APPENDIX I AIRPORT GOLF COURSE

Federal Aviation Administration
ENVIRONMENTAL IMPACT STATEMENT
FOR
REPLACEMENT RUNWAY AND TERMINAL EXPANSION
AT
PORT COLUMBUS INTERNATIONAL AIRPORT

**Airport Golf Course Alternatives Analysis
Associated with Replacement
Of Runway 10R-28L
Port Columbus International Airport**

Subject: Port Columbus International Airport (CMH) Partial Airport Layout Plan Update
 Airfield Planning Report Associated with Replacement of Runway 10R/28L

Airport Golf Course Reconstruction Preliminary Cost - Routing Option "A-1"							
Revised January 12, 2005							
Assumes 12 New Holes + 6 Existing Holes on Current Golf Course Property Only

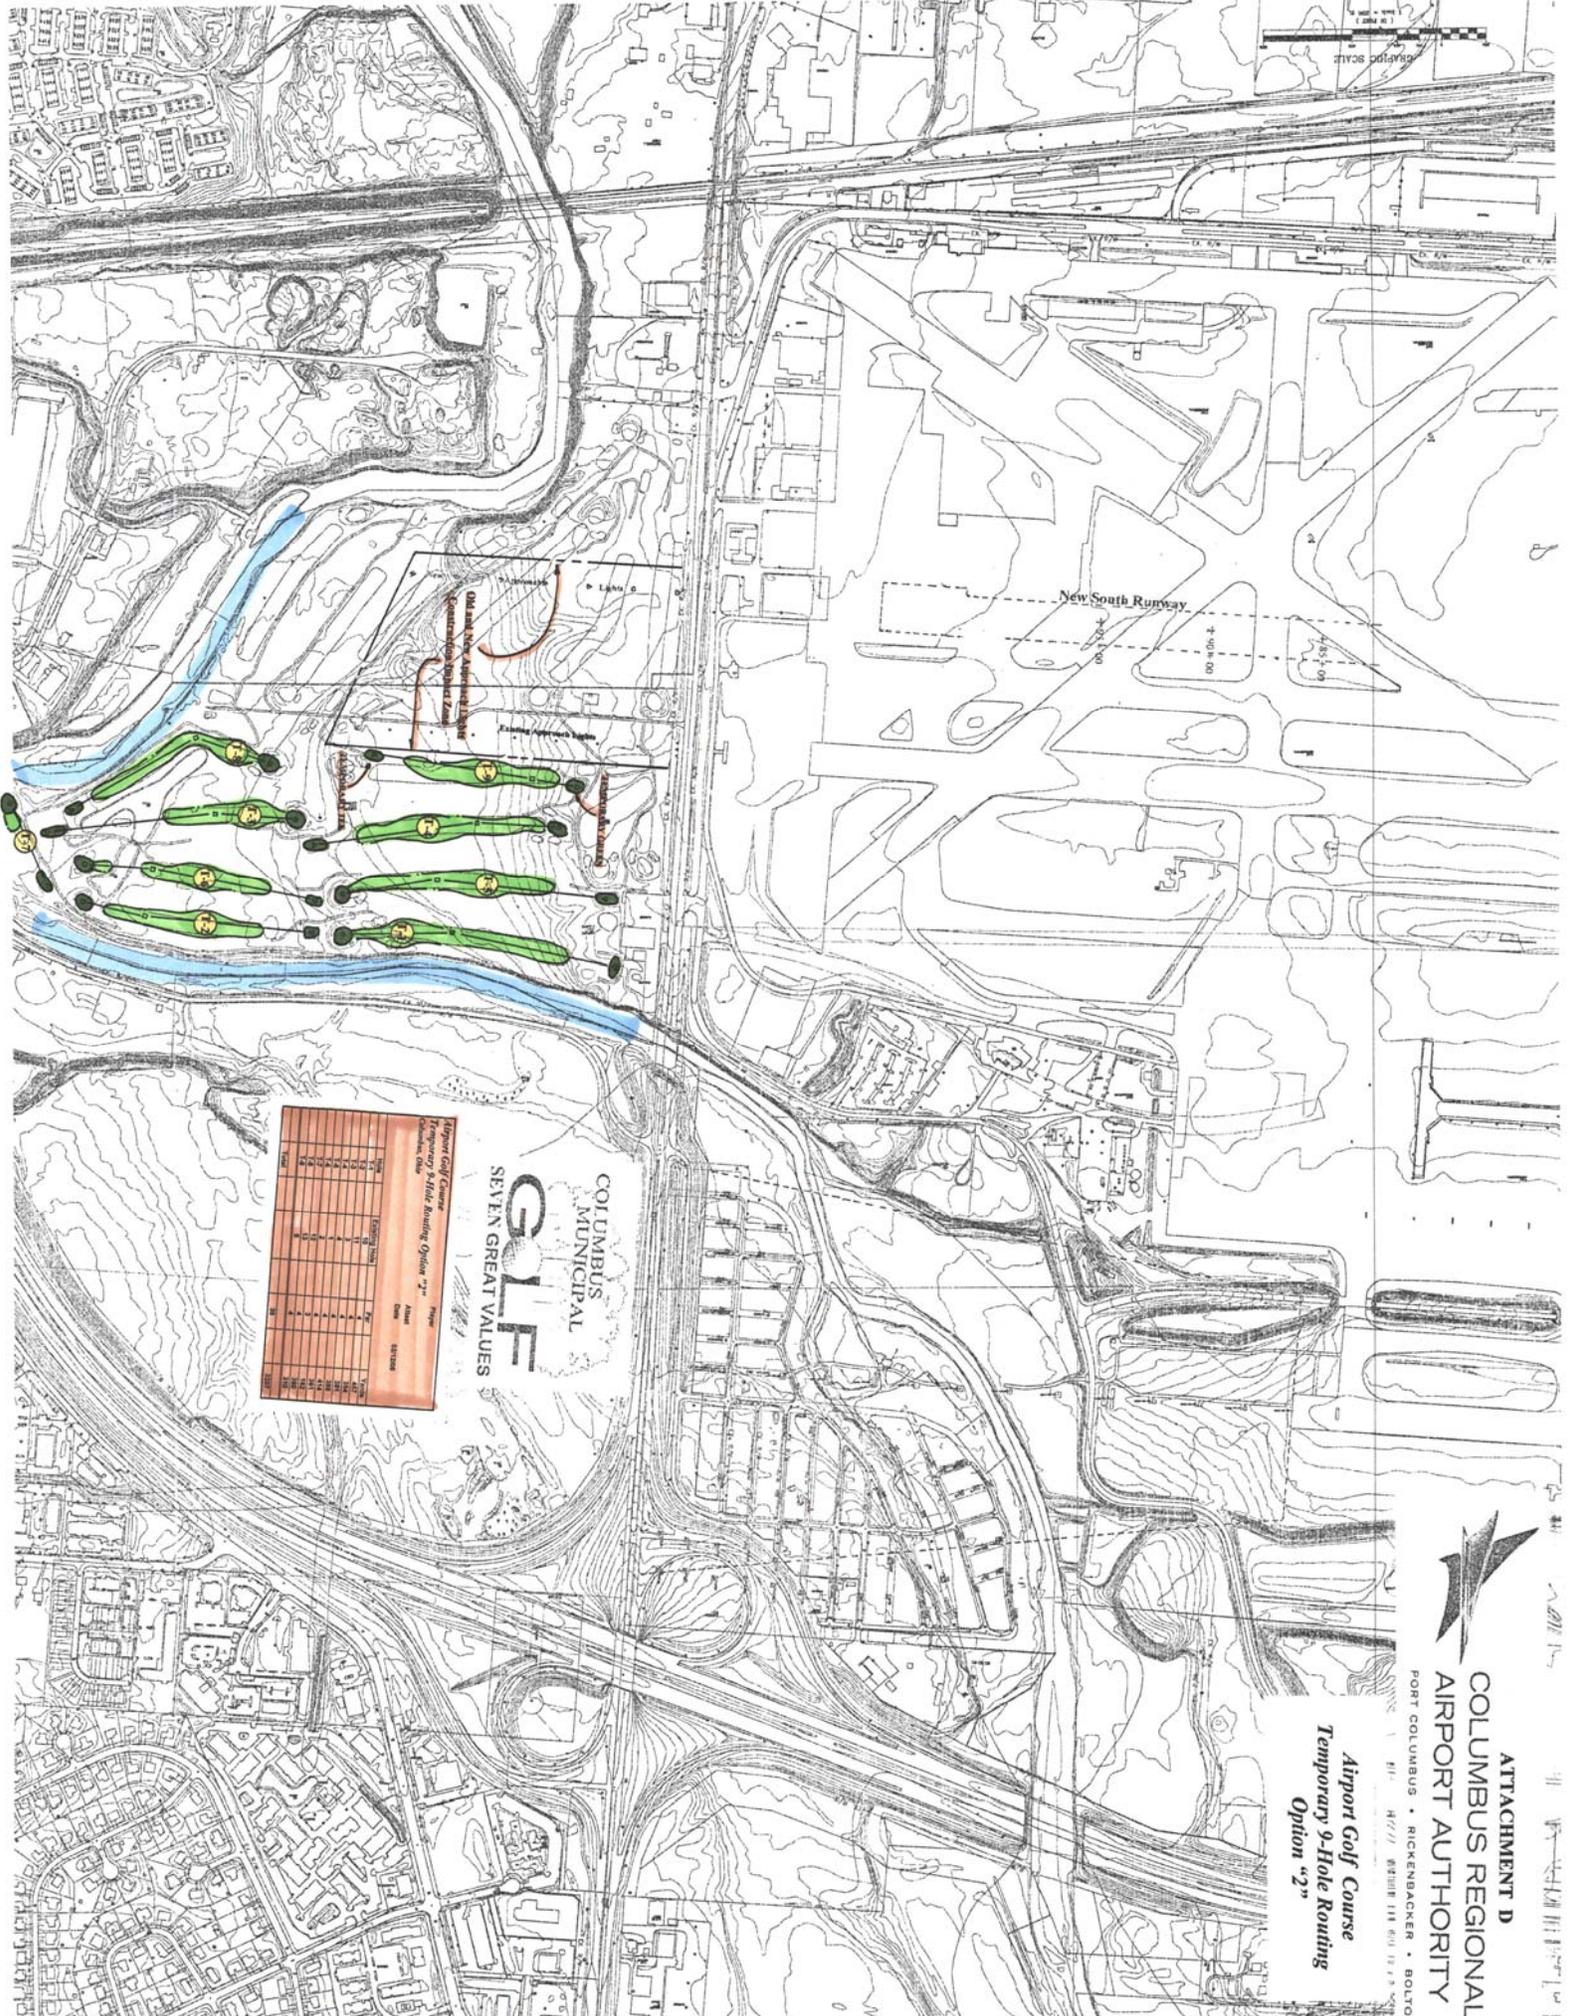
November 23, 2005. FAA Memo from Sam Lakhani, AGL-471 to Katy Jones, DET ADO. The memo states that Tech Ops have no prior knowledge of option A-1 plan as mentioned in the ALP Airspace memo (Section 4.7). The DET ADO provided AGL-471 with an 8-page fax of correspondence related to the Airport Golf Course. The resolution was that CMH would have to submit a FAA Form 7460-1 when the proposed golf course redesign was completed. This was conveyed to the airport sponsor in the airspace review comment letter dated December 15, 2005.

Requested Action: Please review the attached “Airport Golf Course Studies, Option A-1, January 12, 2005” and provide your written concurrence with the following assumptions:

- Golf holes may not be located between the new MALSR nor will golf shots be allowed between the new light towers.
- Golf shots will be played away from or toward the lights but not over them.
- In the final design of the new course, it is also assumed that the new elevations of golf course features (tees, greens, bunkers, etc) will NOT be any higher than the existing golf course features.
- Golf activities such as a part of the tee, fairway, or green can be within the 400-foot light plane.

January 10, 2005. Email from Leo Espino (FAA) to Ron Dixon (URS – Airport Consultant). (In response to the December 10, 2004 email). The FAA stated that, “Based on the attached sketch, Golf activities, any part of a tee, fairway or green can be inside the 400-foot light plane. Certain elements of the course or activities are allowed provided they should not be closer than 20 feet from the MALSR tower. Planning to plant trees must not penetrate the approach light plane. If there are existing trees on this area, other agencies are involved for environmental study.”

Based on the attached sketch, Golf activities , any part of a tee, fairway or green can be inside the 400 feet light plane. Certain elements of the course or activities are allowed provided they should not be closer than 20 feet from the MALSR tower. Planning to plant trees must not penetrate the approach light plane. If there are existing trees on this area , other agencies are involved for environmental study.
